## **STANDARD FIELD SERVICE BULLETIN**

FSB Number	CHRAEFSB2016-33 Rev. 1
Author	Tony Bryan
Date	12/05/2016
Subject	Moto Z Play - Blank Display (Cracked Glass)
Model Affected	XT1635-01, 02, 03
Level Of Repairs	Level 2

**Figure 1.0 - Display Glass Edge Crack**

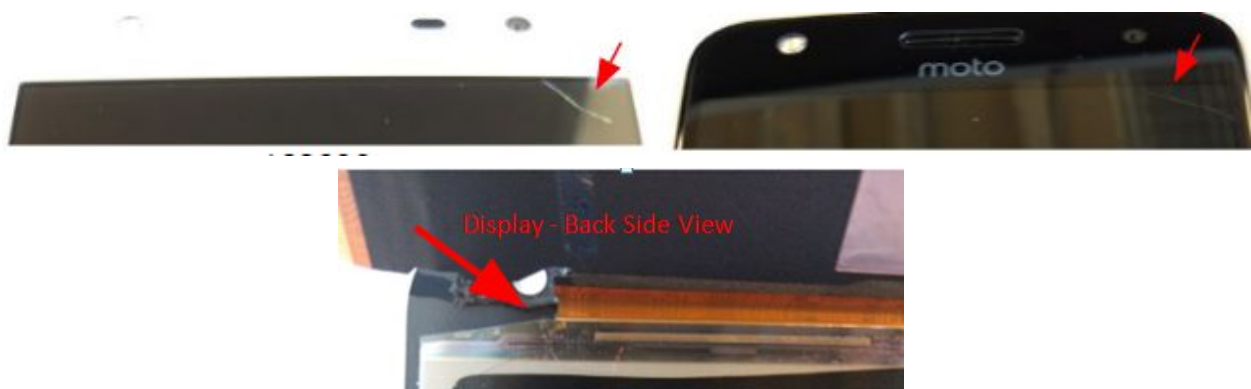
Motorola is aware of a potential field return issue with the Moto Z Play product related to Display. Some devices were returned by users with complaints of either “No Display” or “No Turn On”. Engineering analysis determined that the symptom was actually Blank Display and the cause was edge cracking of the display glass. The cracking typically occurs at the top right corner location as shown in Figure 1.0 below.

In these specific cases, the internal display glass was found to be cracking along the chamfered edge with no obvious signs of drop damage to either the external lens glass or housings.

Motorola worked with the display supplier to add a CNC Polishing process to help improve edge quality of display glass making it more robust against cracking. Supplier cut-over to 100% CNC Polishing as of December 5, 2016. The 8S Label located on the display flex was updated to reflect this change. See Figure 2.0 below.
